Site Assessment and Inspection Report (SPDES GP-0-15-002, Part IV.C.4)

Name of Facility: Starbuck Island	Permit Number: NYR11D911
Location: Village of Green Island, New York	
Date of Inspection: October 23, 2018	Time of Inspection: 11:30 am
Weather: Cloudy - 46 Degrees	Rainfall Since Last Inspection: 0.08"
Purpose of Inspection: Bi-Weekly Inspection	Inspector: KPB

CONSTRUCTION DURATION INSPECTION REPORT

PROJECT INFORMATION: STARBUCK ISLAND (SPDES ID: NYR11D911)

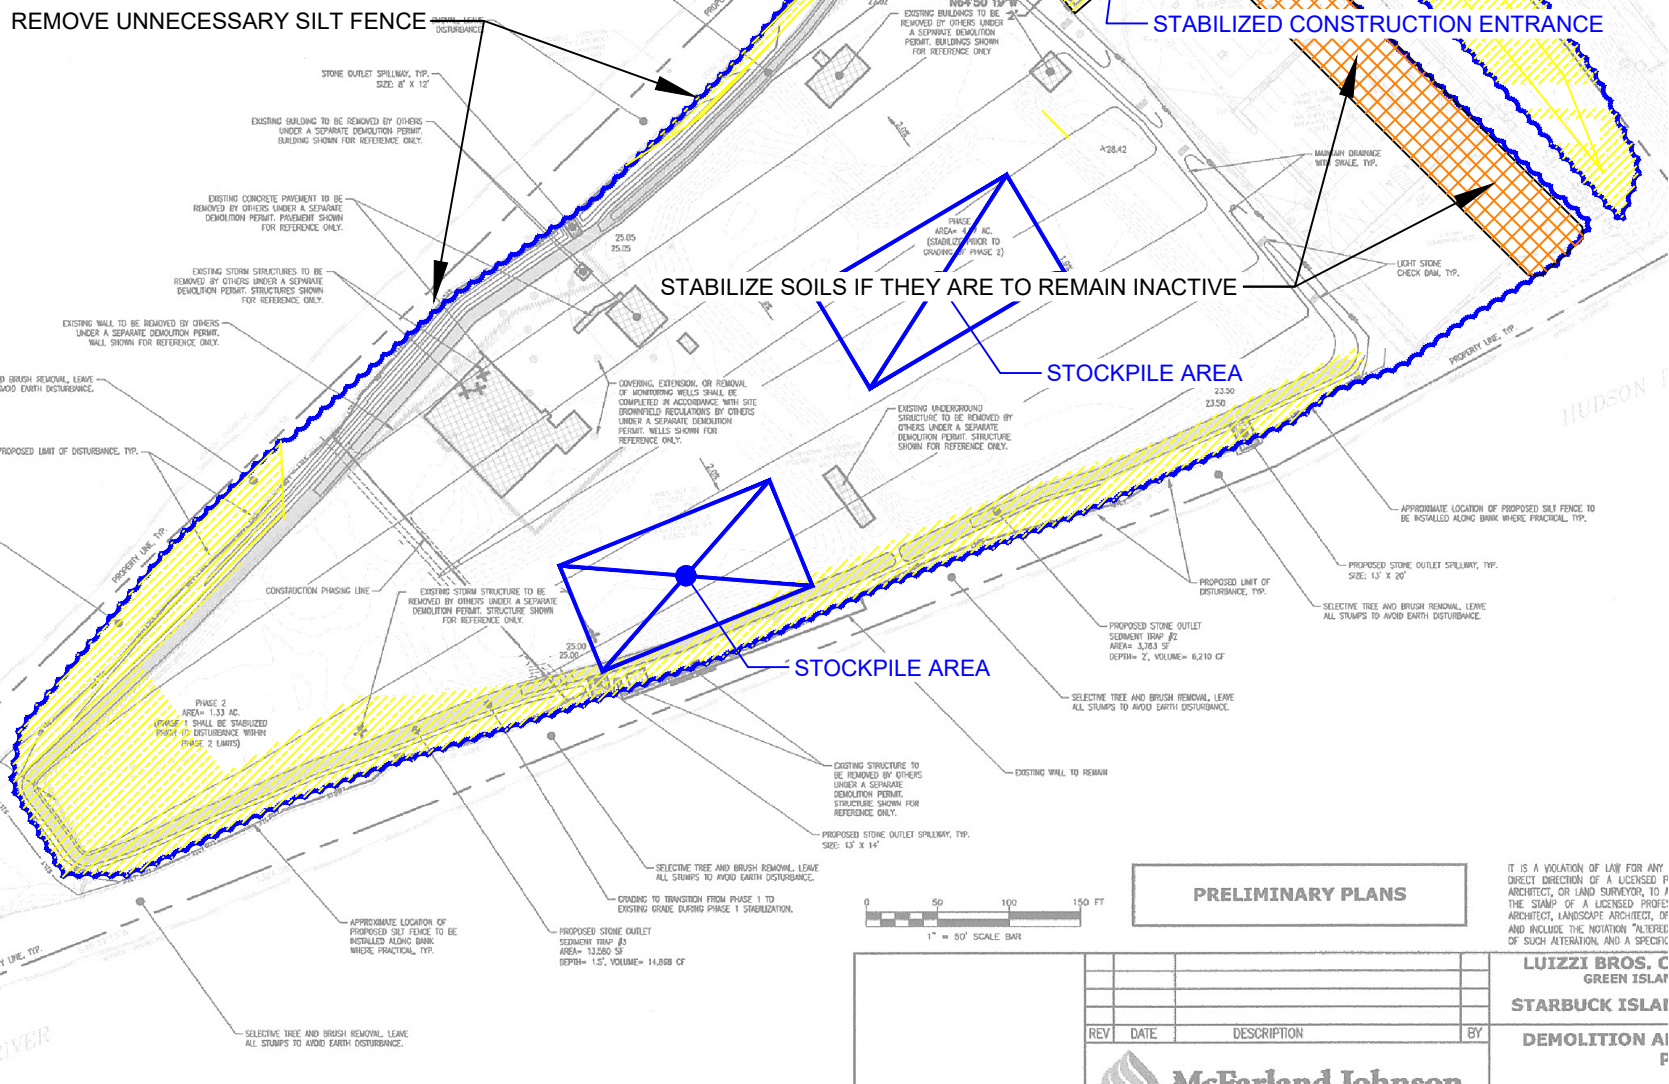
Additional Comments: Monitor slope for erosion and repair, as needed.

Additional Comments: Stabilize soils if they are to remain inactive.

Additional Comments: Remove unnecessary silt fence.

CONSTRUCTION DURATION INSPECTION REPORT

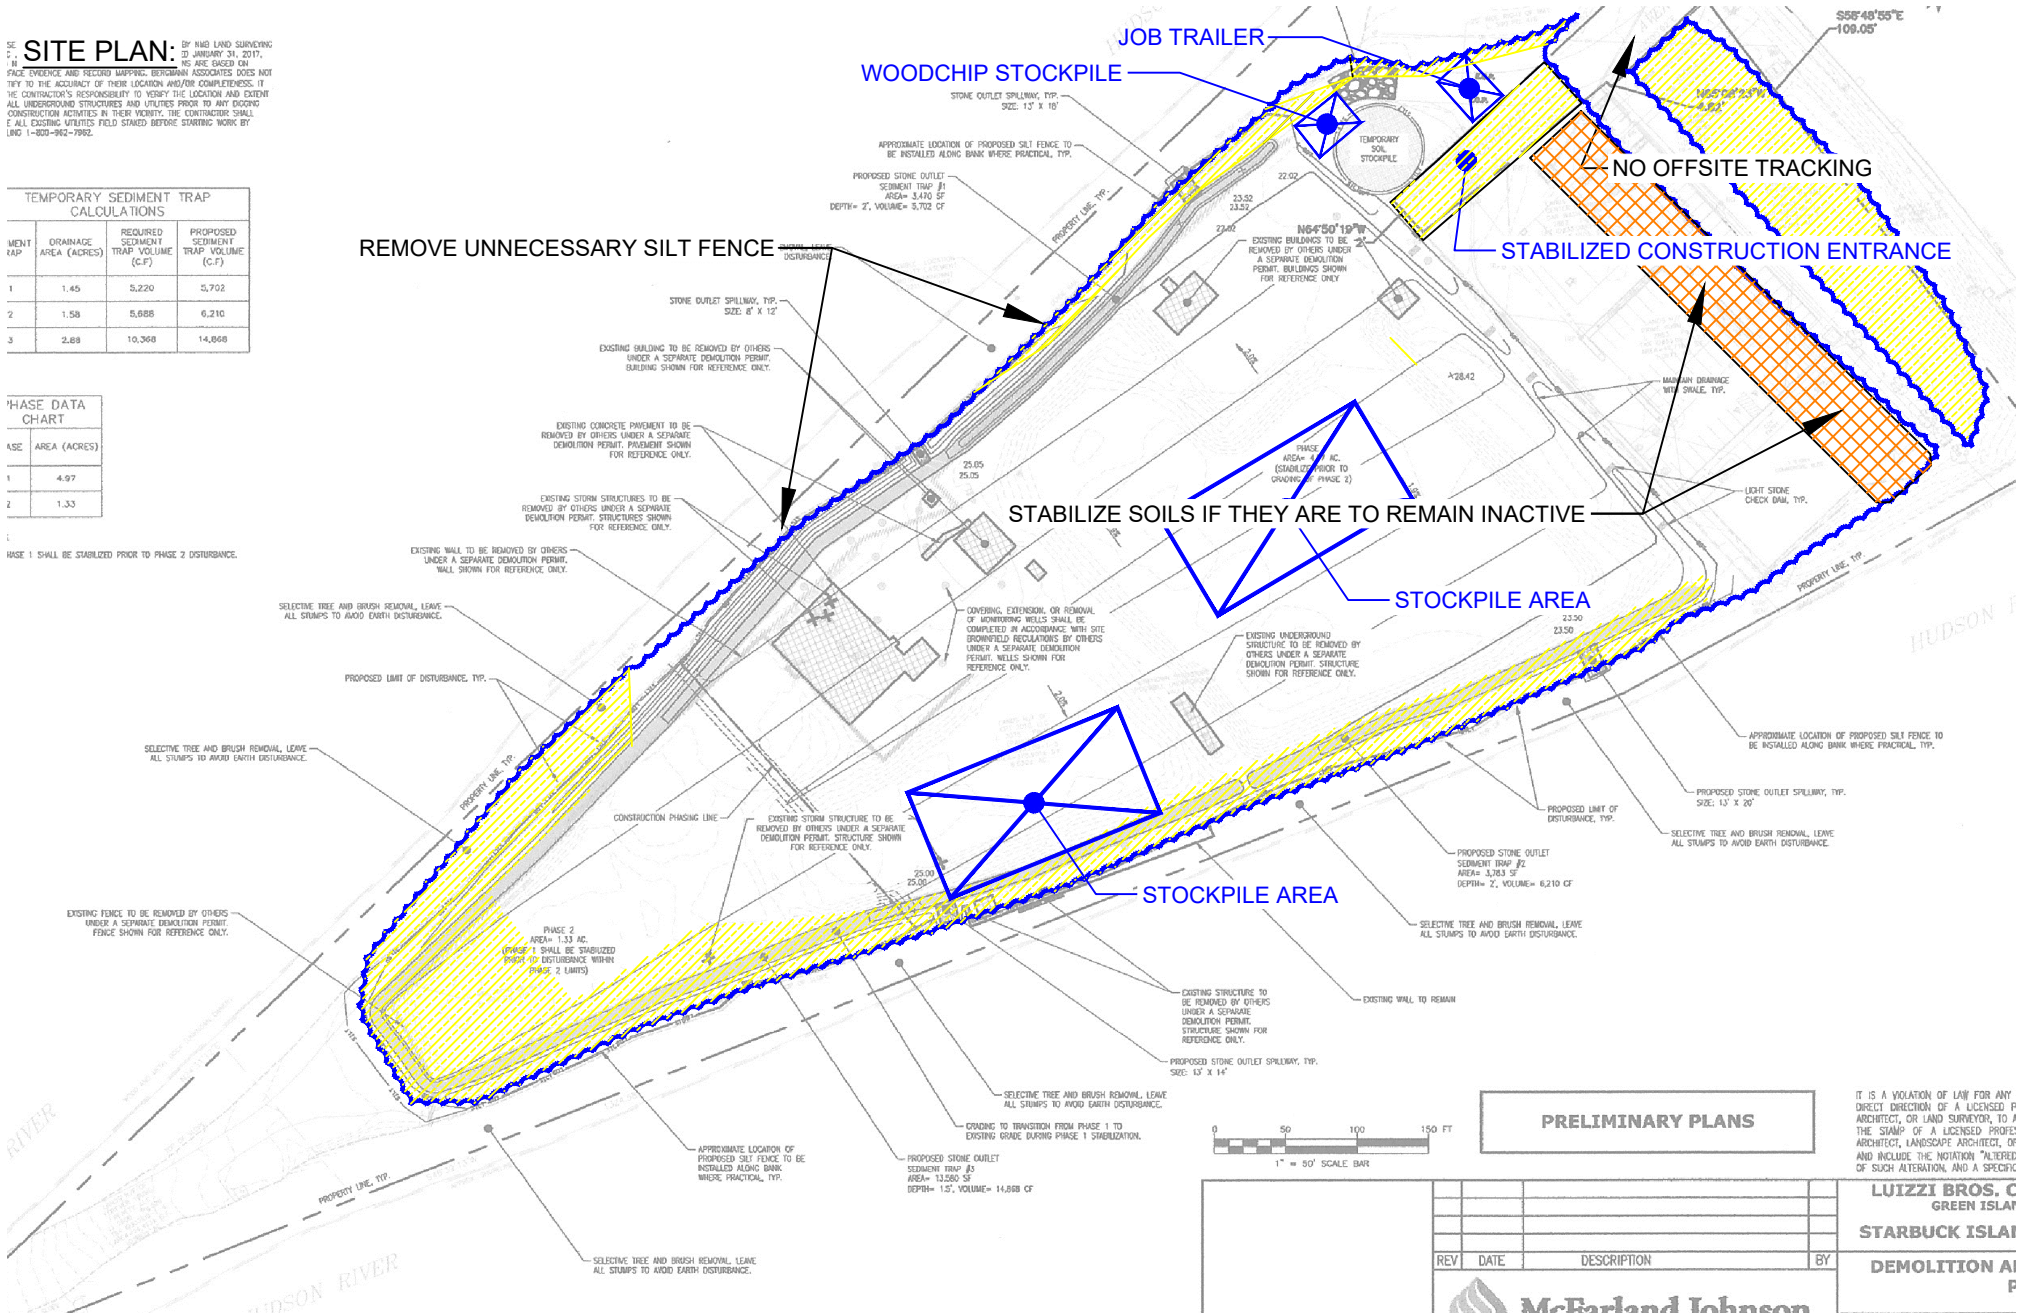
Additional Comments: Monitor slope for erosion and repair, as needed.

Additional Comments: Stabilize soils if they are to remain inactive.

Additional Comments: Remove unnecessary silt fence.
